Stanton Cross Route 2 Highway Works at London Road Roundabout

Proposals for Reducing Impacts on TPO Trees

Wellingborough Walks Action Group

14 June 2023

Figure 2 – Proposed Realignment of Footway/Cycleway

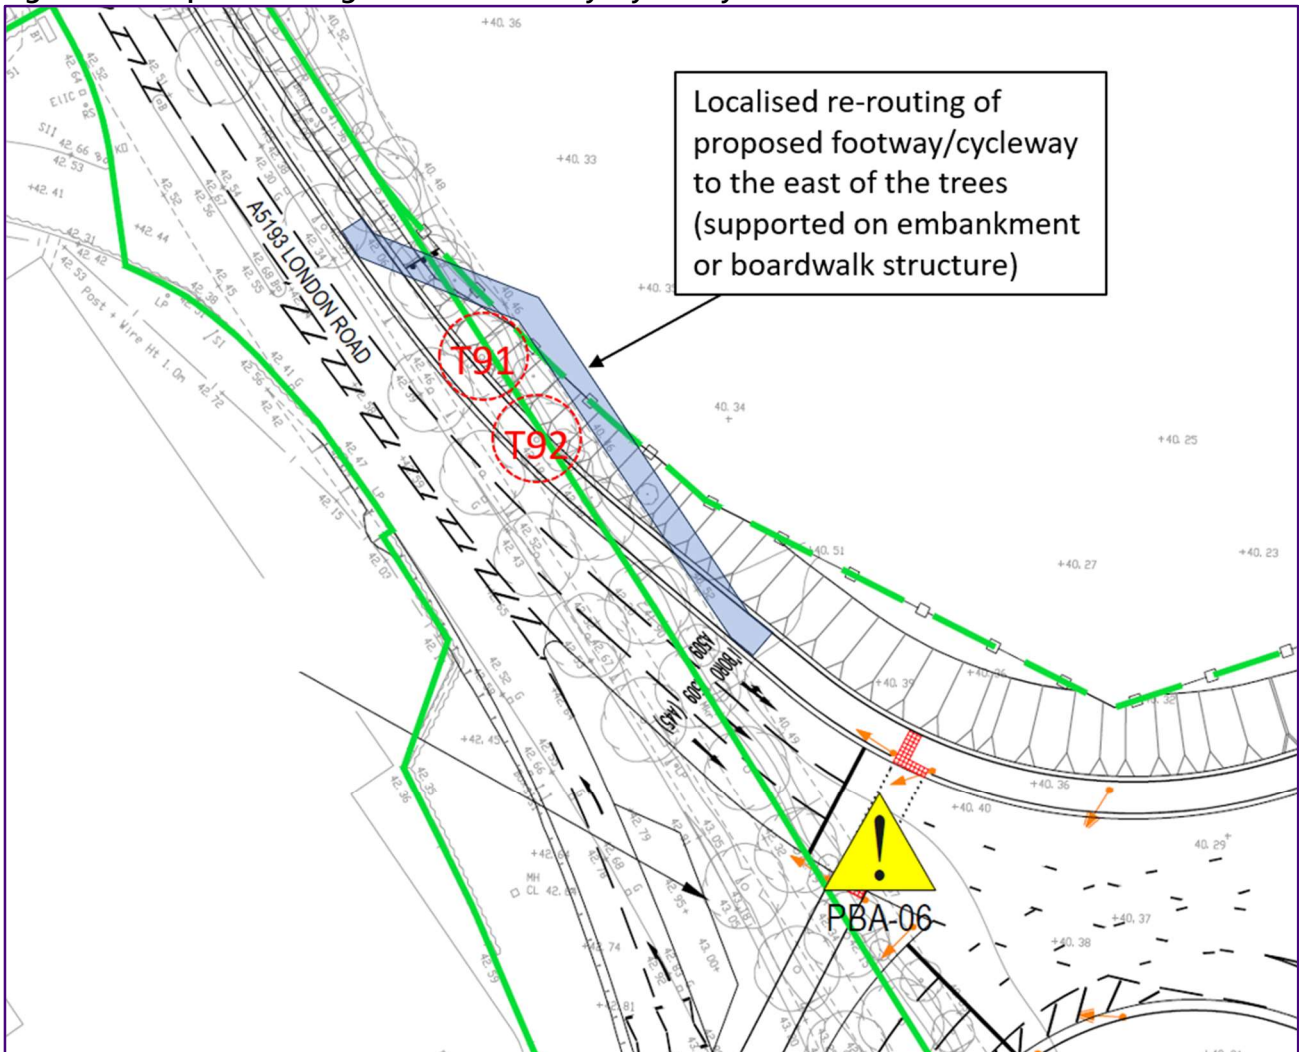
Trees T91 and T92 were not felled in February when adjacent trees in this area were removed. Potential exists to retain these two trees by locally re-routing the proposed footway/cycleway as shown in Figure 2. Adjustment of the highway boundary in this area can be undertaken as part of the S278 process, without affecting the original planning permission.

Figure 4 – Eastern Trees

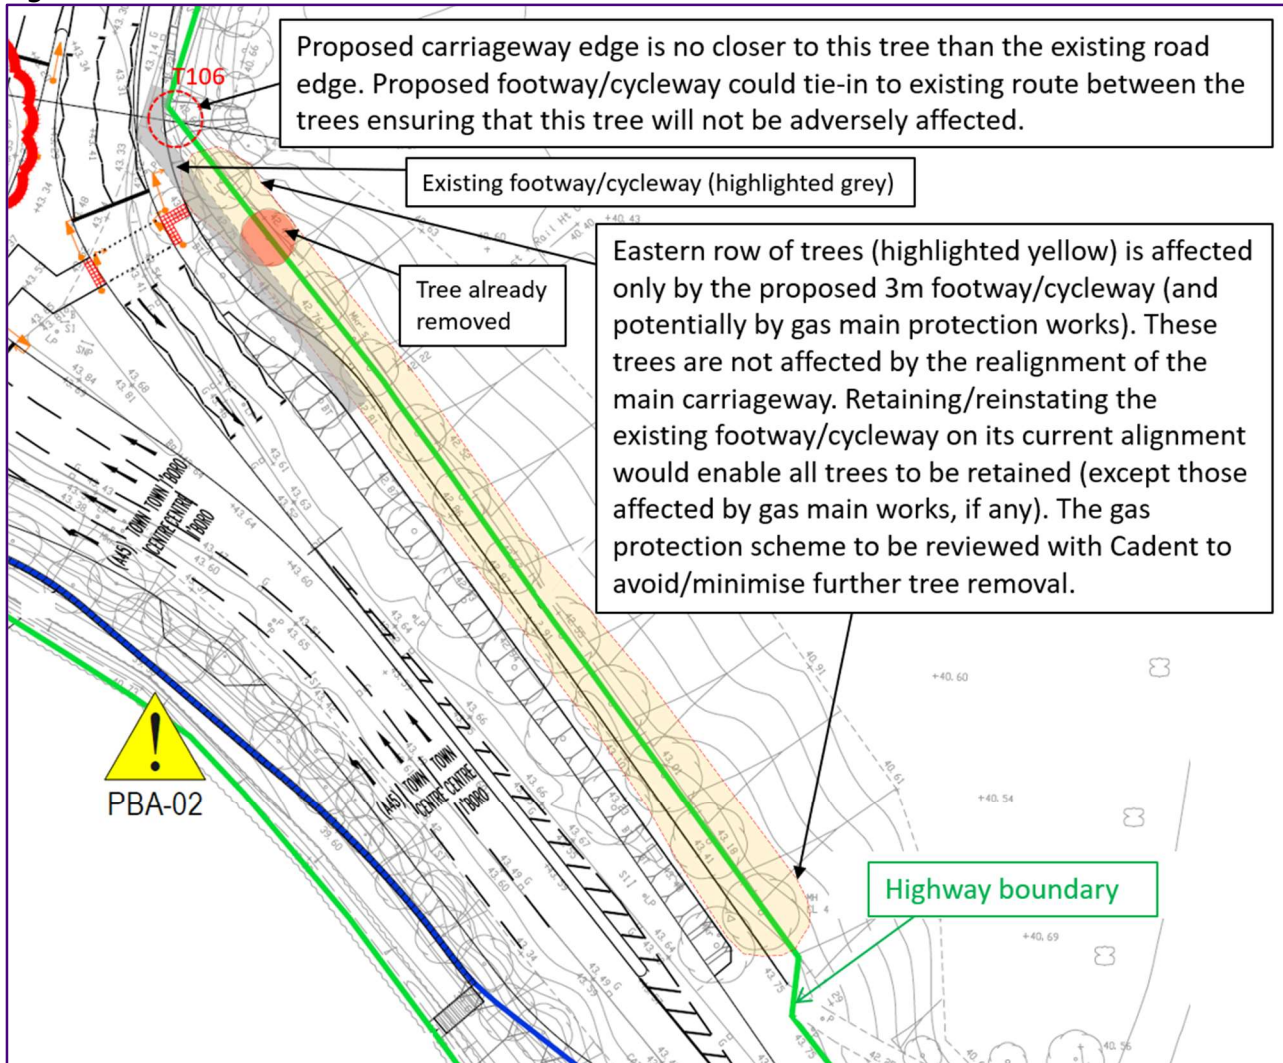
As indicated in Figure 4, the northernmost tree (T106) is not affected by the proposed new kerb line (the new kerb position is no closer to the tree than the existing kerb). By retaining the current footway/cycleway between the trees and tying-in the new footway/cycleway from Embankment (B570) at this point, T106 could be retained.

Some trees at the northern end of this group have the potential to be affected by protection works for the high pressure gas main (operated by Cadent) that crosses London Road to the south of the roundabout. No details have been provided of the likely protection works needed. However, the trees predate the gas main and were in place when the main was laid. There will be no traffic loading on the pipe, where the gas main crosses the avenue of trees, so the extent of protection works needed in this area is unclear. It is recommended that designers work with Cadent to identify a solution that minimises any unnecessary adverse impacts on the protected lime trees.

Figure 5 – Western Trees – Option 1

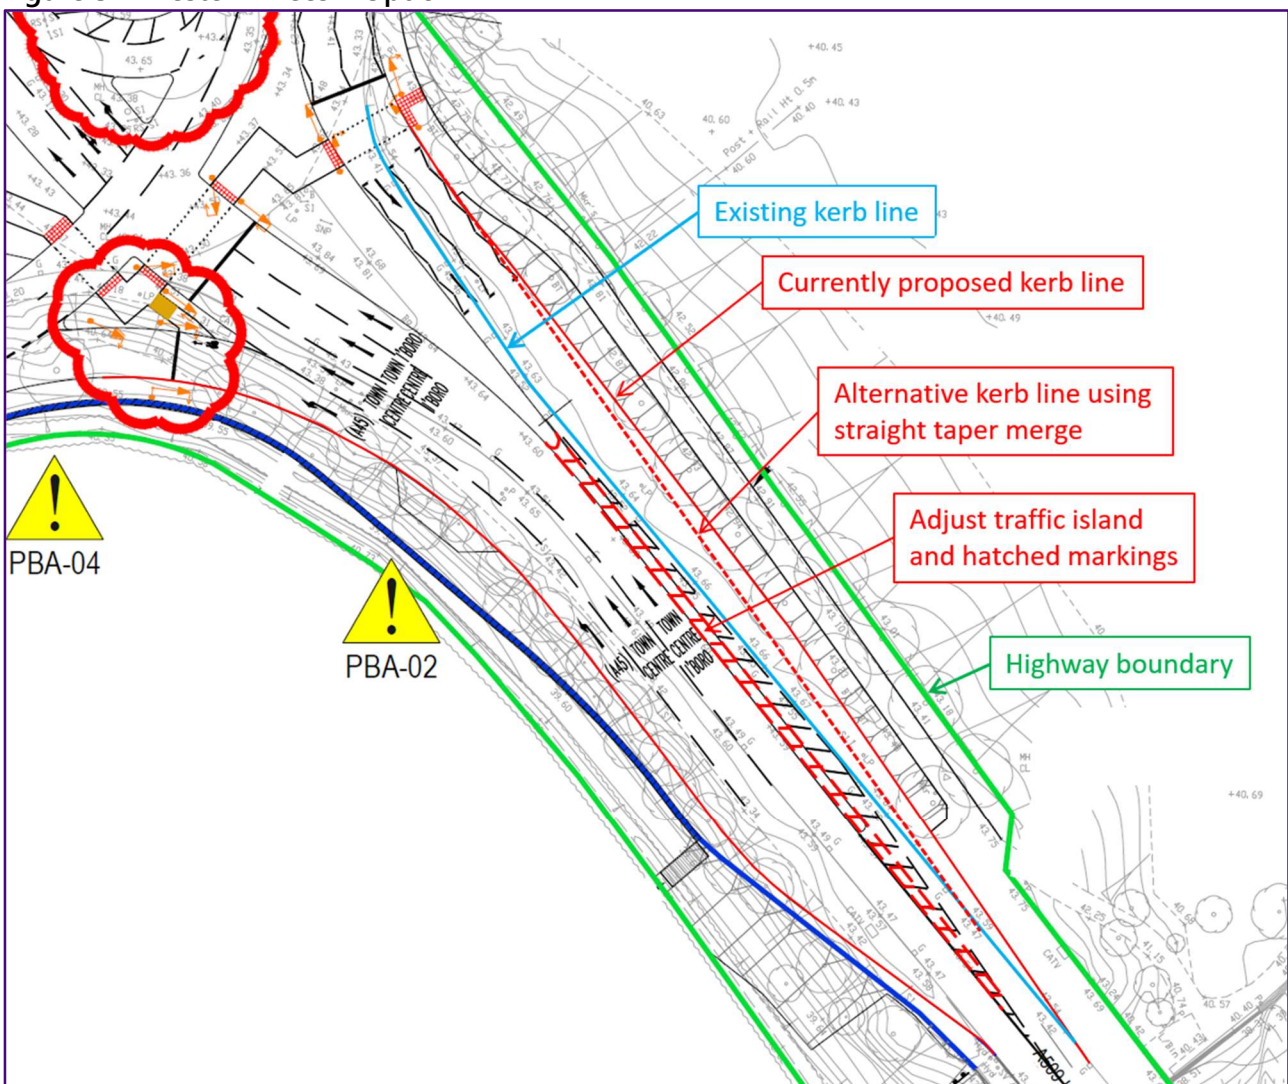
The proposed widening of the London Road (south) arm of the junction to accommodate six traffic lanes (4 northbound and 2 southbound) requires the carriageway to be widened on both sides of the road. As shown in Figure 5, the current design proposes to relocate the eastern kerb line close to the row of lime trees, particularly at the southern end of the row. The extent of carriageway widening is dictated by the length of the proposed traffic island (which separates northbound and southbound traffic lanes) and the merge design. A more compact arrangement could be considered, utilising a straight taper merge (as shown dashed red in Figure 5), together with shortening of the central traffic island and adjustments to the hatched markings.

This arrangement would move the proposed kerb line further away from the trees. The extent to which this would reduce the impact on the trees would need to be confirmed by specialist arboricultural assessment. Lime trees are known to have a relatively compact, "oblique" (heart

shaped) root structure which typically spreads much less widely than “lateral” or “tap” root structures. Subject to further investigation, this minor adjustment to the traffic island and merge taper has the potential to save a number of trees.

Figure 6 – Western Trees – Option 2

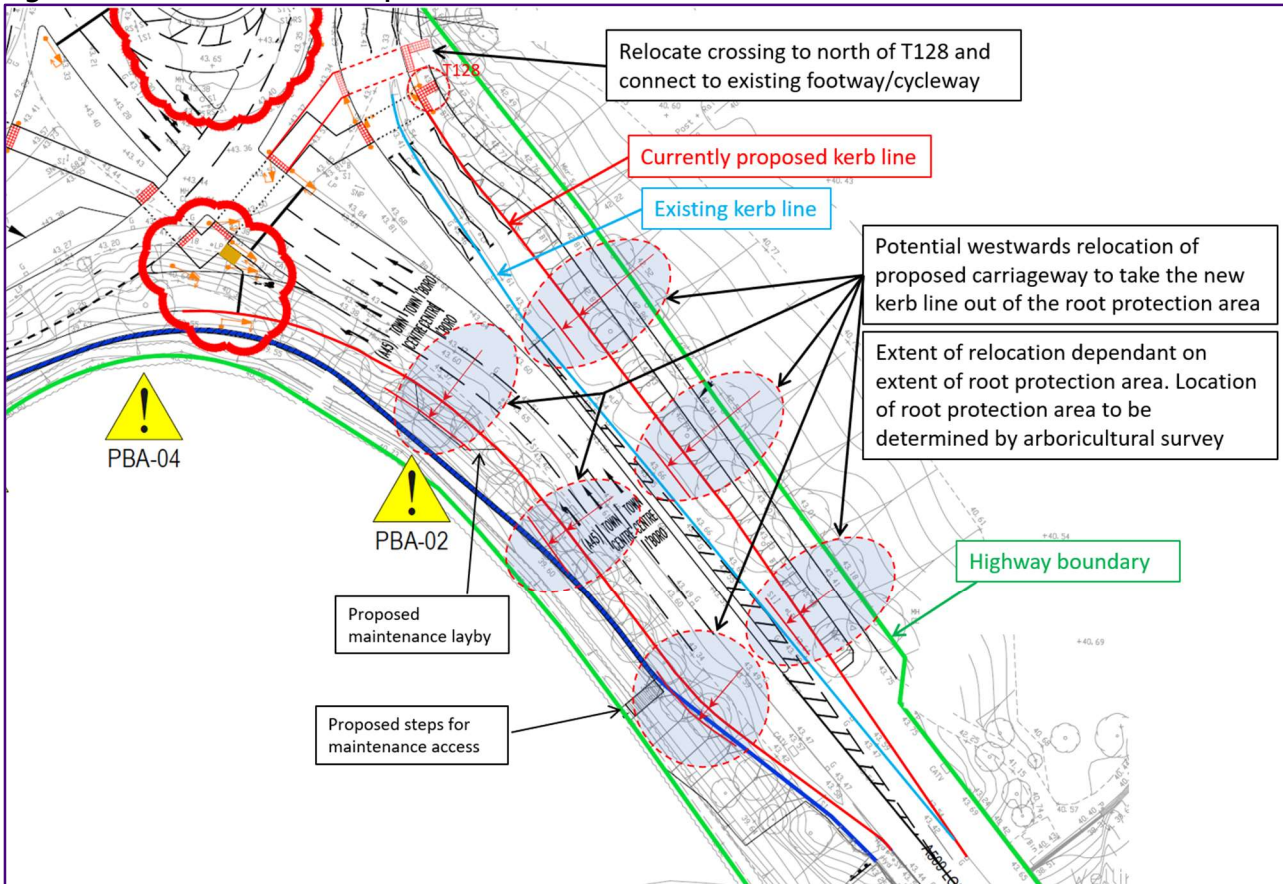
An alternative solution would be to realign the London Road (south) arm of the junction westwards by a few metres to take the carriageway construction out of the RPA’s of the trees, as illustrated in Figure 6.

An arboricultural survey of the tree roots using Ground Penetrating Radar (GPR) scanning or hand-dug trial excavations, will be needed to determine the extents of RPA’s. This will identify the amount by which the road alignment needs to be adjusted in order to avoid/minimise further tree loss.

Adjustments to the western kerb line, to accommodate movement of the carriageway away from the trees, can be undertaken within existing highway limits as indicated above. Some small adjustments to the line of the proposed retaining wall (shown in dark blue) are likely to be needed at the southern end, together with small adjustments to the proposed maintenance steps. The proposed maintenance layby would need to be relocated to an alternative location or removed. Again, these modest changes can be accommodated within the normal S278 design process.
